Project: Clarks Point and Port Heiden RPSU
Projects Modular Power Plant
Assembly

Addendum No. Two

DRAWING TITLE:
USED OIL BLENDER
25 GALLON HOPPER
FABRICATION

M5.6

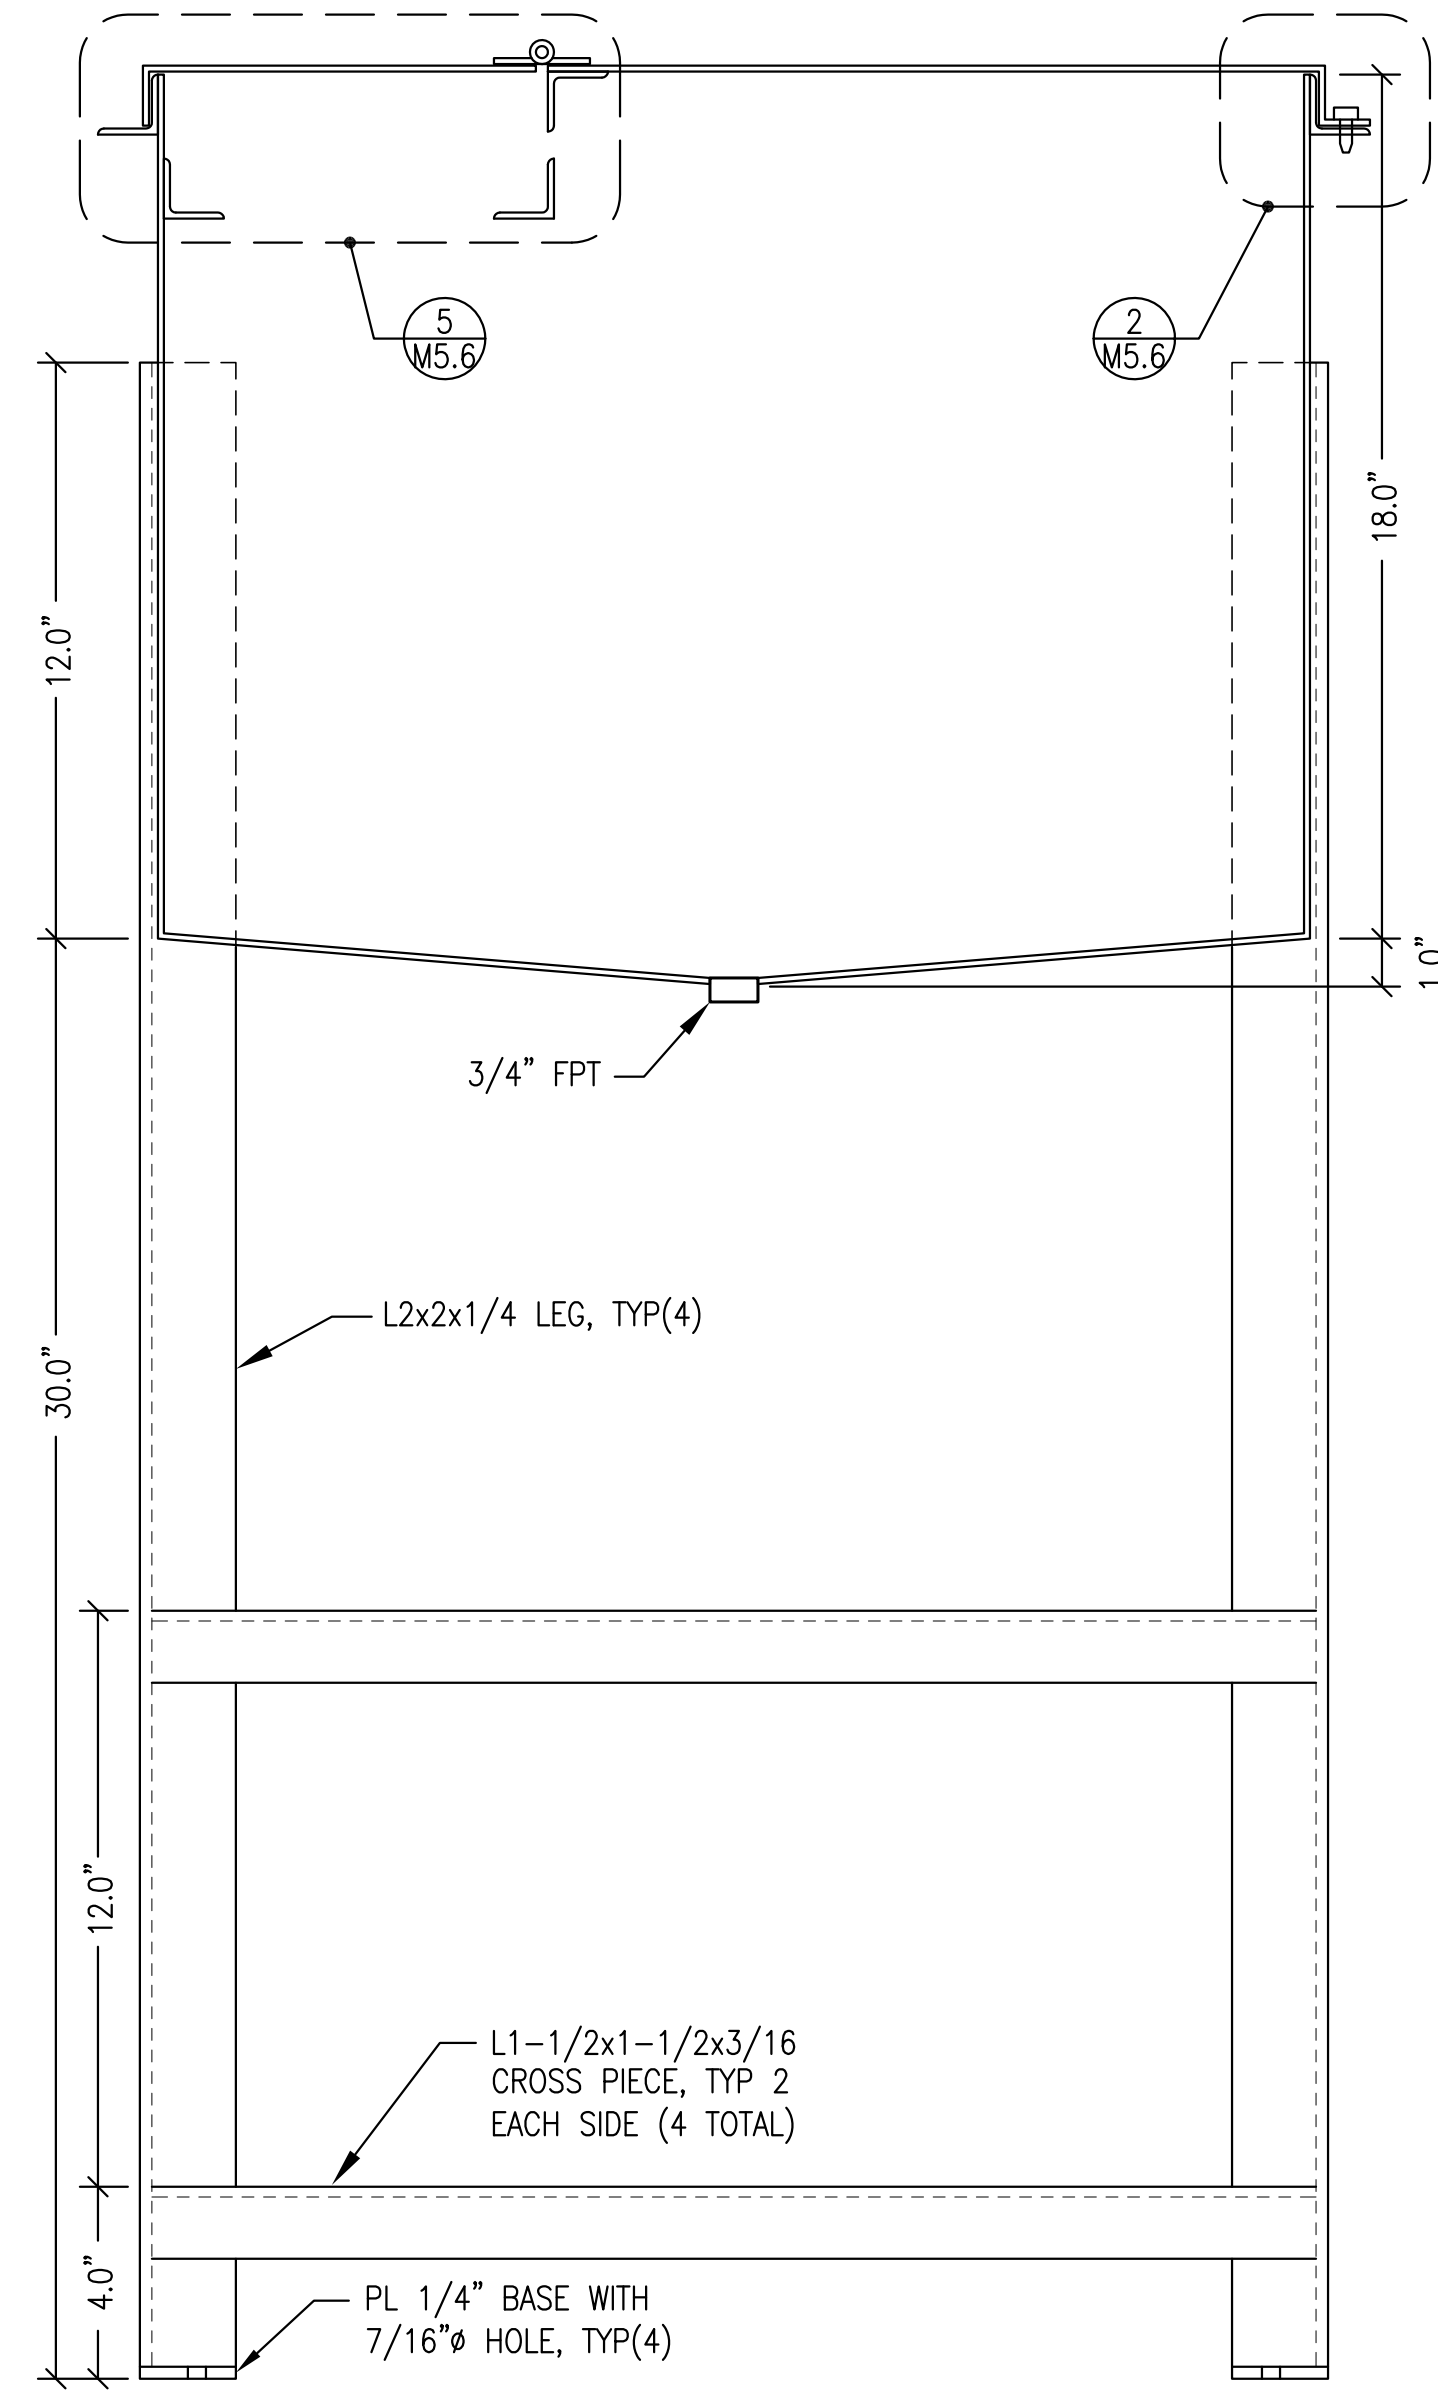
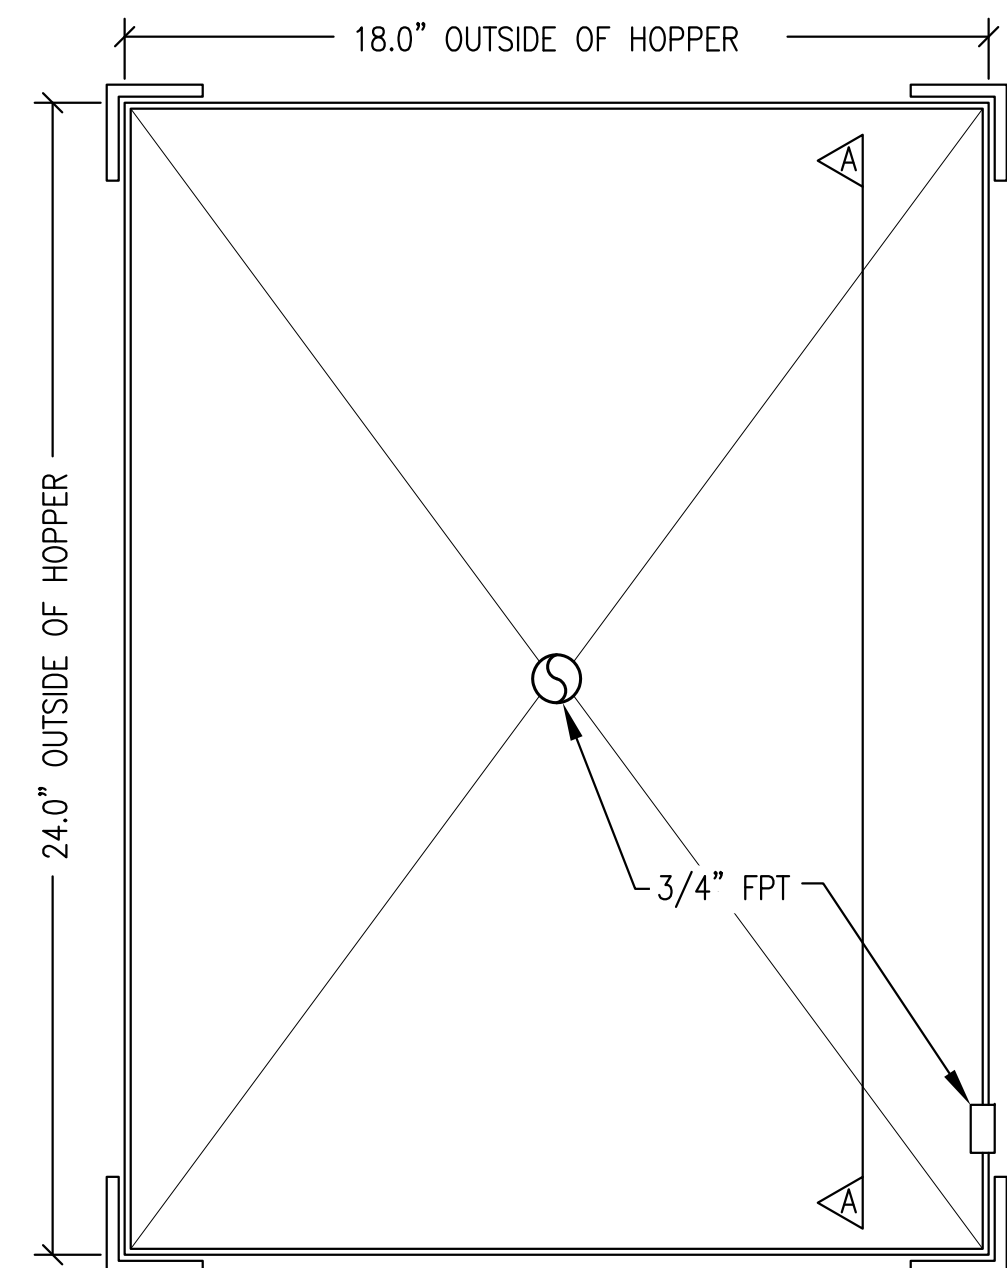
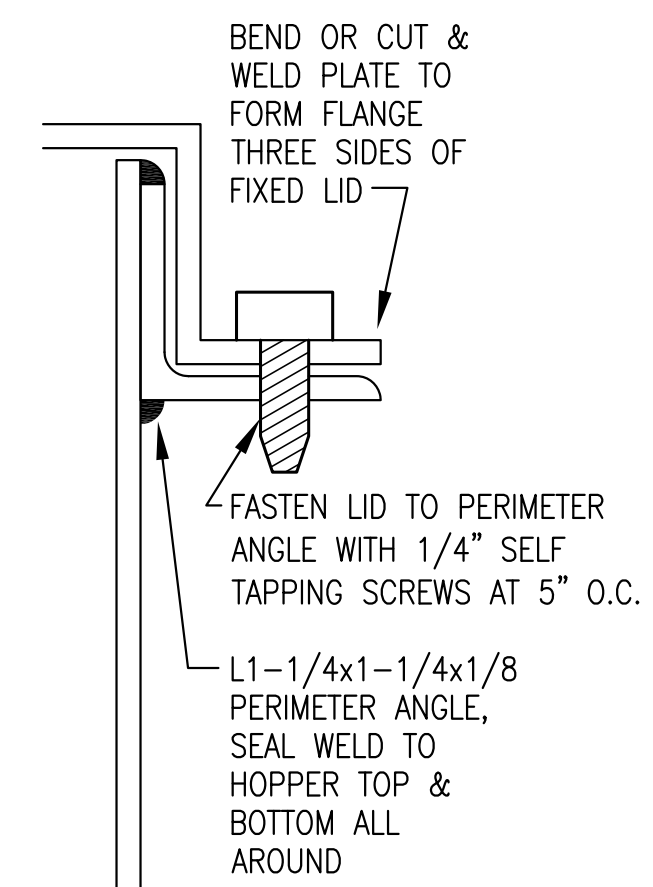
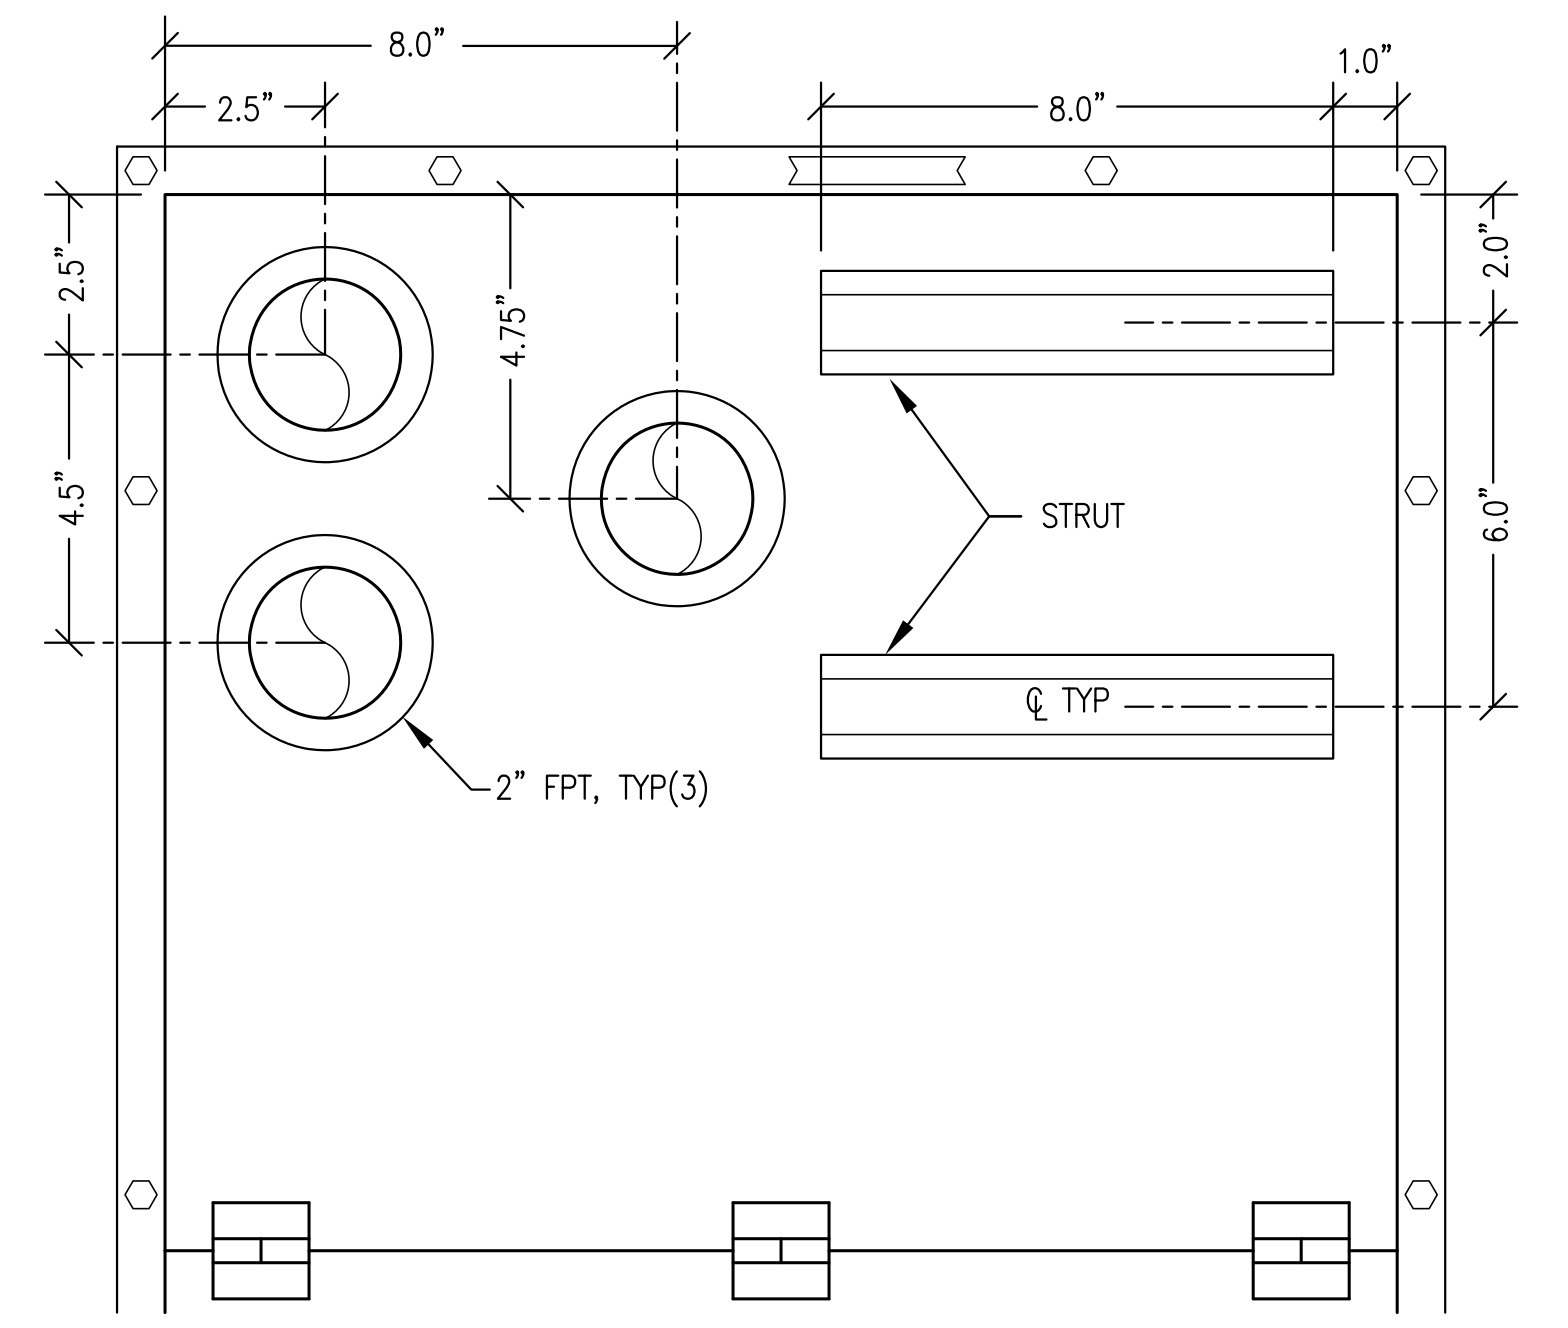
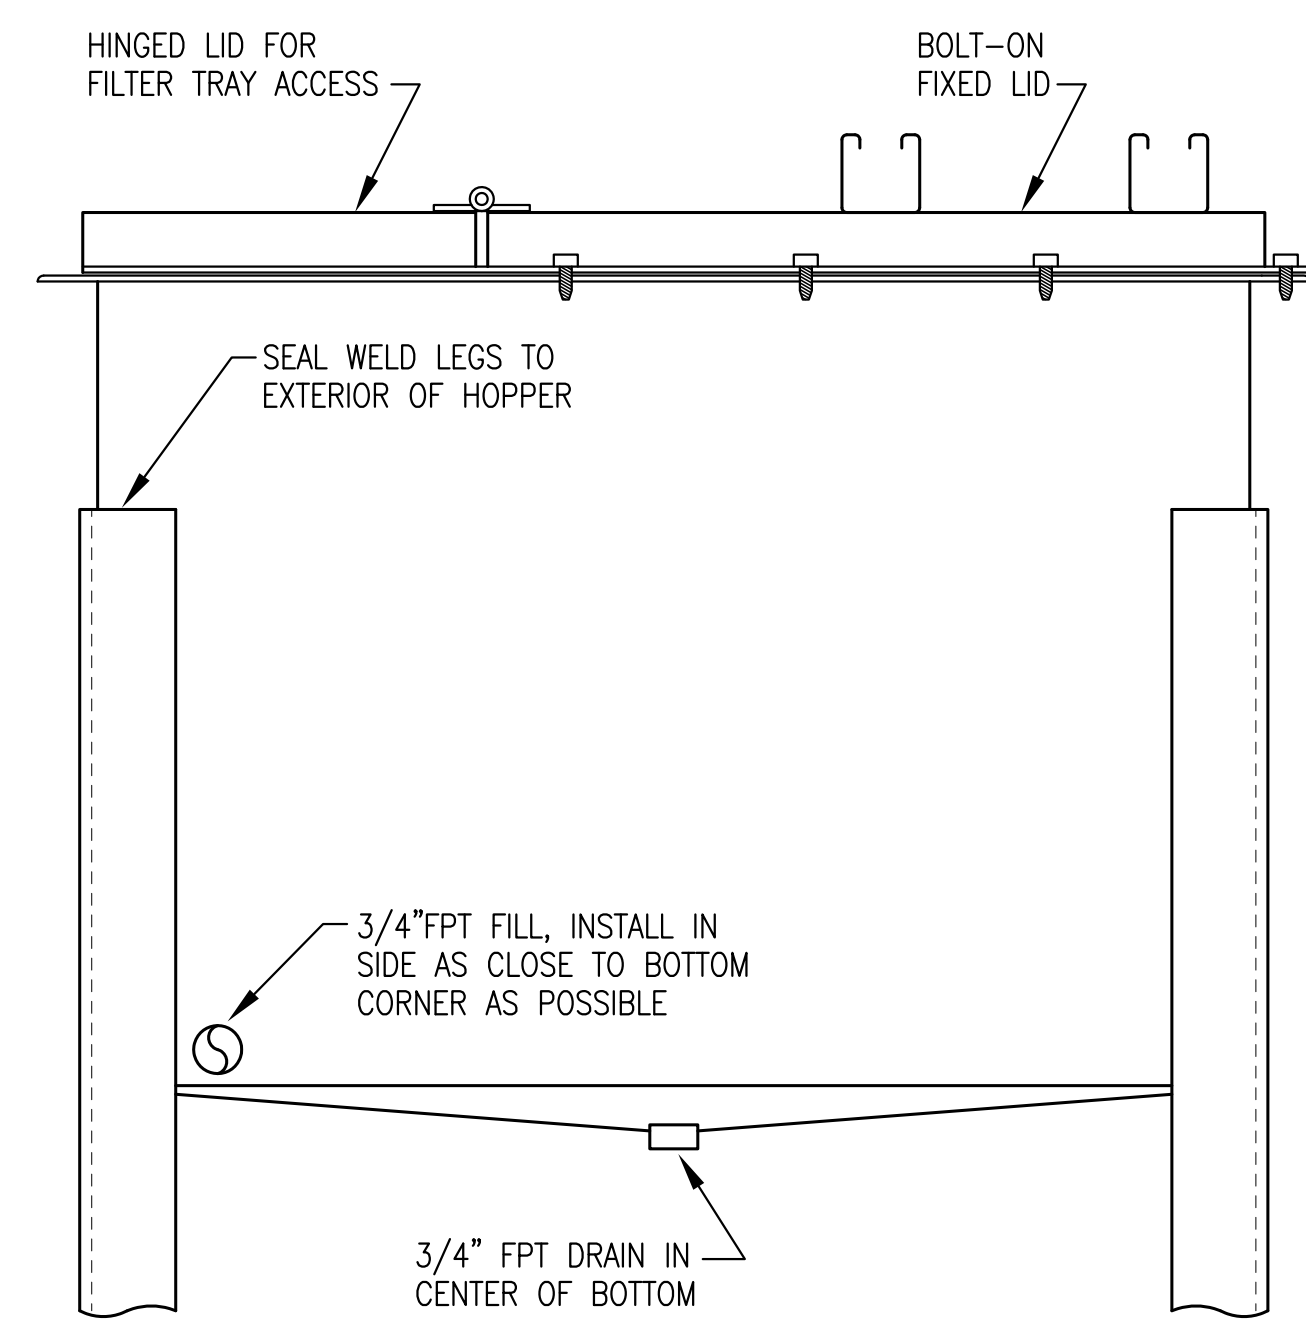
1) **Q:** The drawing index lists **M5.6**, but it is not included in the plan set. Can you please provide this drawing?

A: Please see **Attachment No. 1**.
